Interactive comment on “Groundwater level changes on Jeju Island associated with the Kumamoto and Gyeongju earthquakes” by Soo-Hyoung Lee et al.

Received and published: 12 May 2017

Fig. 1. RC1_reply_(1) question (Fig. 2)

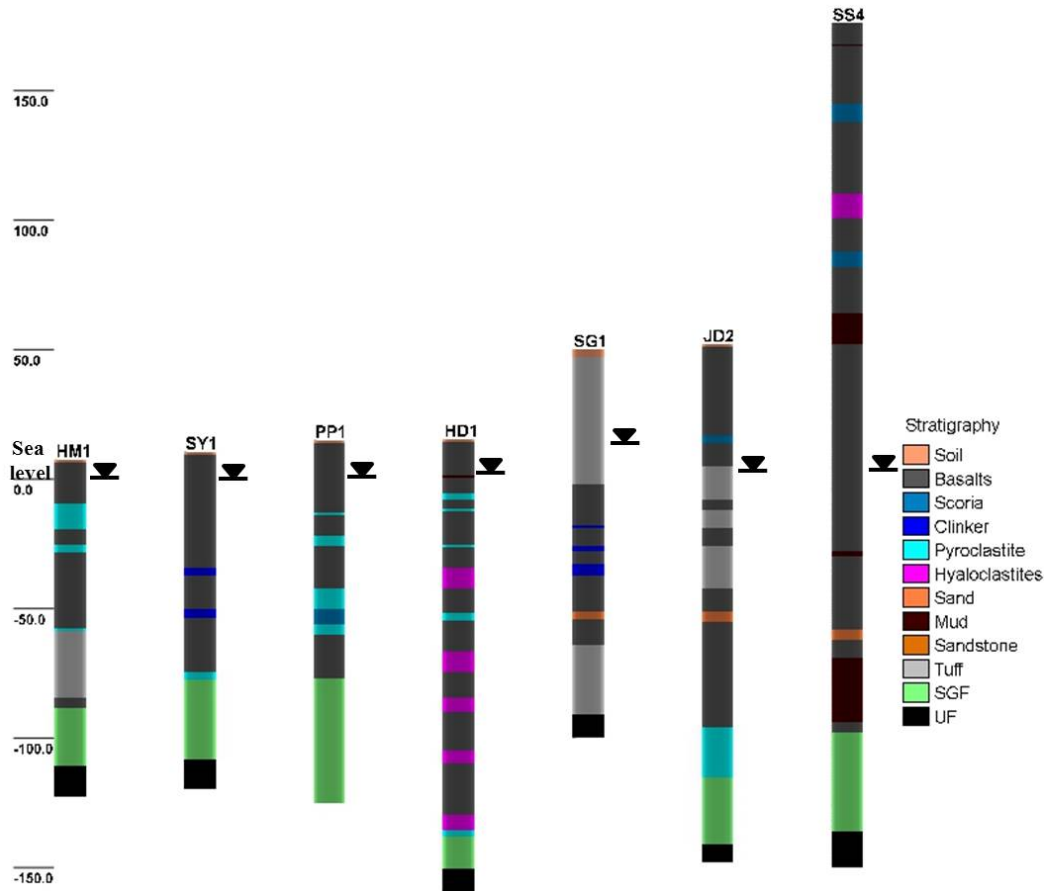
(1) The authors described the lithology and groundwater wells in Jeju Island, but no information is provided about aquifer and the well structure of these wells. I suggest that a cross-section of the hydrogeology setting with location of these wells would be insightful.

1) Reply - We agree with your comments. Accordingly, we added Fig. 2 (Geologic logs of the monitoring wells). As described in the revised manuscript (the lines 4 - 9 on the page 3), based on the geological logs of the monitoring wells that are mostly drilled to UF (Unconsolidated Formation), porous lava flows of repeatedly accumulated layers cover the basement rocks. Especially, in the higher altitude area, more abundant lava flows appear with the existence of many volcanic units (including clinker, scoria, sediments, pyroclastites, and hyaloclastites etc.) between the lava flows. Consequently, groundwater moves along complicated flow paths under the influence of numerous hydraulic parameters. (See the figure below)

Fig. 2. RC1_reply_(2) question

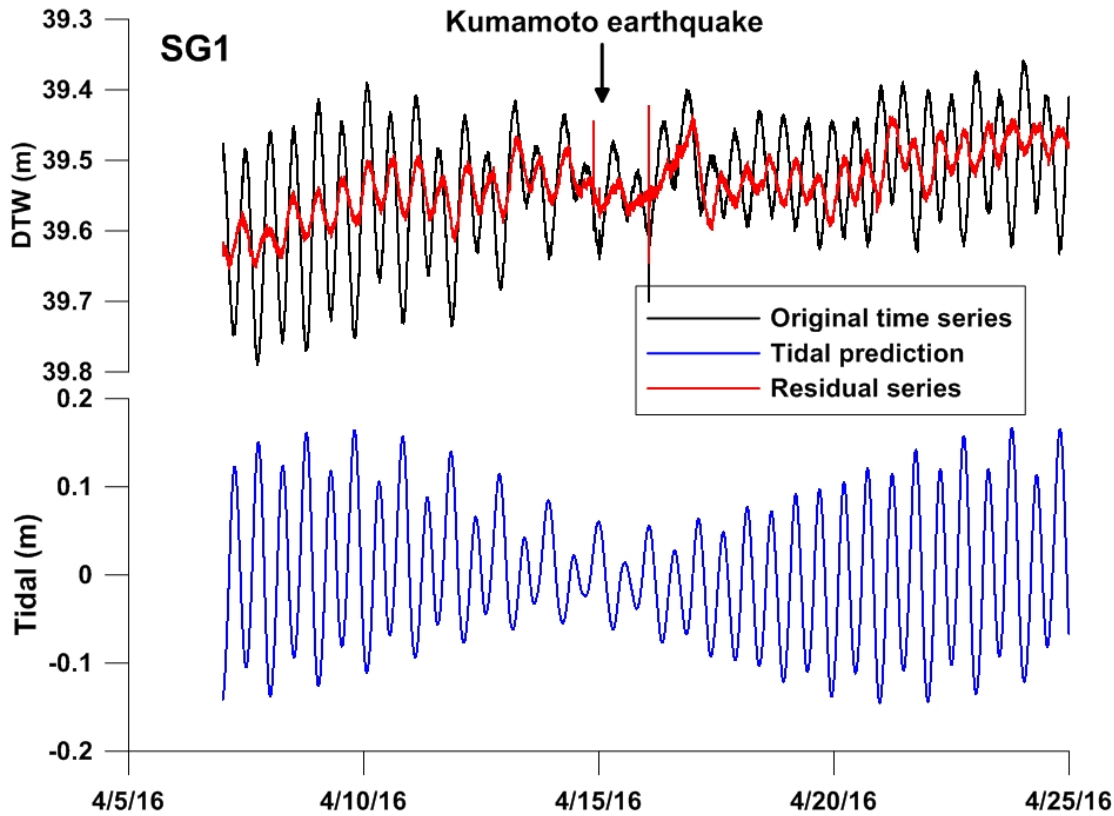
(2) Equation 1, the authors use the moving average method to filter the relative low frequency ocean tide. However, in my understanding, the ocean tide has different frequencies (ranges from low to high frequencies). What's more, I think if you want to filter the low frequency signals, why don't you use the high-pass filtering? I am doubting about the result by moving average method in filtering the low frequency data. The ocean tide can be calculated and removed by several existed programs such as Spotl, Baytap.

2) Reply - We agree with your comments. Tidal effect was eliminated from the measured groundwater level time series, by considering ocean tidal prediction and using T_TIDE MATLAB code (Pawlowicz et al., 2002) that was available from the server (<http://www.iamg.org/CG-Editor/index.htm> or <http://www.ocgy.ubc.ca/~rich>). (See the figure below).

Fig. 3. RC1_reply_(3) question (Fig. 5)

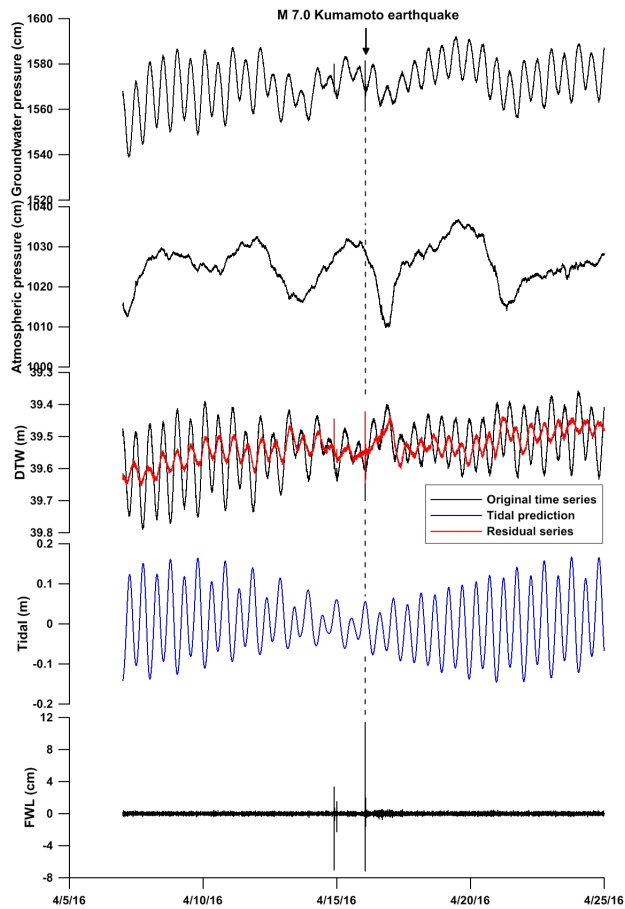
(5) The author said X_t is the raw groundwater level corrected for atmospheric pressure, but they didn’t show what method was used in the correction.

5) Reply - The raw groundwater level was corrected for barometric pressure effect, by simultaneous atmospheric pressure measurement with the groundwater level measurement. Please refer Fig. 3. (See the figure below).
